**Testimony submitted on behalf of
The Stormwater Infrastructure Matters (S.W.I.M.) Coalition
NYC DEP Public Hearing on Proposed Amendments to Chapter 31 of Title 15 of
the Rules Governing House/Site Connections to the Sewer System
October 31, 2011**

Re: **NYC DEP's Proposed Amendments to Chapter 31 of Title 15 of the Rules Governing House/Site Connections to the Sewer System (a.k.a. "NYC Stormwater Rule")**

RE: Comments on: (i) Proposed Amendments to Chapter 31 of Title 15 of the Rules Governing House/Site Connections to the Sewer System; and (ii) Draft Guidelines for the Design and Construction of Stormwater Management Systems

Figure 1- Brooklyn Stormwater Release Rate

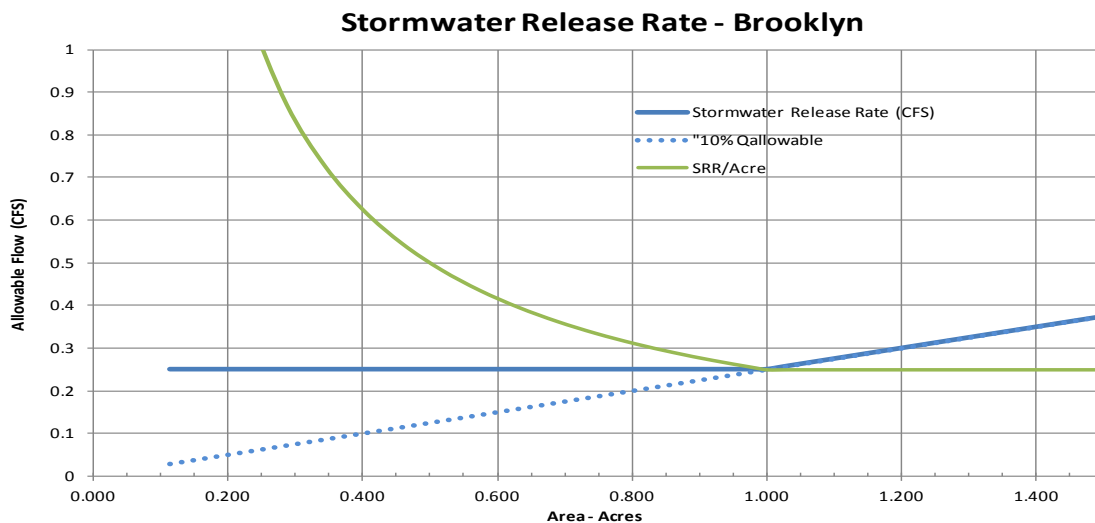
What this table shows first is the commendable reduction in release rates. For a new ¼ acre impervious site, the allowable flow is 0.63 cfs, so 10% of that is 0.063 CFS. As 0.25 is greater, that is the value used, not 10% of the Allowable flow. It also shows that when viewed from an impervious area perspective, the smaller sites have a much smaller reduction required compared to the larger site, though both are certainly much more restrictive than the past criteria. This is also shown in Figure 1 below. For areas 1 acre or above the requirements work out to be a simple value of 0.25cfs/acre, but for a .25 acre site the result is 1 cfs/acre. This leads to widely varying results, with potentially significant reductions of effectiveness toward meeting the goals of the program. For example, the runoff for an individual one acre impervious development project would be limited to 0.25 cfs of discharge into the combined sewer system from the site. But, if the impervious acre were divided evenly among four separate development projects, the summed runoff would be allowed to discharge at a rate of 1.0 cfs for the same amount of impervious surface (i.e., 0.25 cubic feet per second from each of the four quarter-acre parcel). While still significantly lower than past practices, this is a 400% increase from the single site requirements. This also translates to a smaller over all site requirements for storage that is addressed later in this review. The one acre site would require stormwater management practices sized to capture approximately 1.1 inches, while each of the four properties would only need approximately .65 inches, a 40% reduction in storage requirements (Figure 2).

It is very hard to understand whether this criterion will meet the desired CSO reduction goal. To answer this question an analysis of expected future development grouped by impervious footprint needs to be merged with the stormwater release rate criteria. The statement on page 3 of the draft that most of the runoff comes from larger buildings is very misleading. The relationship between runoff and impervious area is proportional, and several small buildings will have the same impact as one large one if the total impervious footprint is the same. The statement is made (page 7) that controlling the first inch of runoff from 10 % of the impervious area served by the combined sewer system would greatly reduce CSOs. If any significant proportion of the building permits (by impervious area) are less than an acre -- as it seems they would be in New York City -- the proposed standards should be reviewed and adjusted, as needed, to ensure the goals of the program are met. A spread sheet that was used in this analysis is included as Appendix A.

Figure 2- Brooklyn Green Roof Storage Volume - 5 Year Intensity

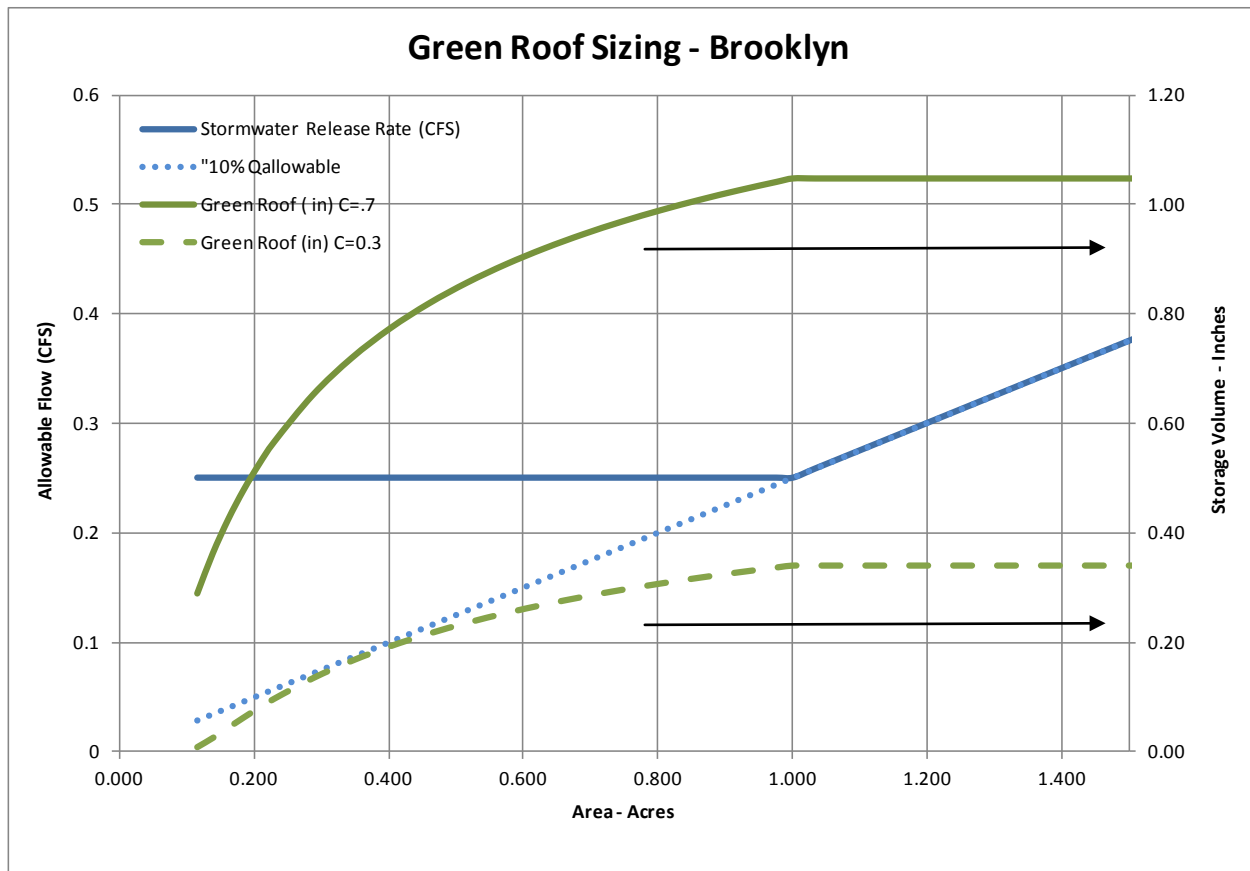
A consequence of requiring an artificial rational method approach with inflated "C" Values is that the *Guidelines* undervalues the effectiveness of green roofs and other green infrastructure techniques at meeting the proposed performance standard. This is counter to the statement made on page 21 in the NYC Green Infrastructure Plan that detention of one inch is 60% less effective than

infiltration (or evapotranspiration / reuse) of this volume. To be equivalent in reducing CSO, green infrastructure practices should be sized smaller than grey to achieve the same result. By not accounting for the improved performance, the cost of using green infrastructure is artificially increased (deeper green roofs, larger bioretention areas, etc.). This is not reflected in the required approach, thus the Green Infrastructure approach is not fully rewarded.

It clearly seems that it would be much simpler to set a performance standard requiring capture and removal of an inch over the impervious surface for volume reduction techniques (e.g., green roofs, rain gardens, underground infiltration, and possibly rainwater harvesting). It would be essentially be equivalent or superior (for smaller areas) to the proposed stormwater release rate -- even without considering the expected superior performance of green volume reduction systems in regard to CSO reduction. Moreover, this would be more consistent with the statement (page 7) that controlling the first inch of runoff from 10 % of the area would greatly reduce CSO volumes, since it appears that statement is derived from the NYC Green Infrastructure Plan, which based its analysis on modeling one inch of infiltration (i.e., volume reduction). Additionally, when one starts with a falsely modified equation, it would not be able to be included in system wide hydrologic modeling, and it is difficult to understand how new knowledge can be included.
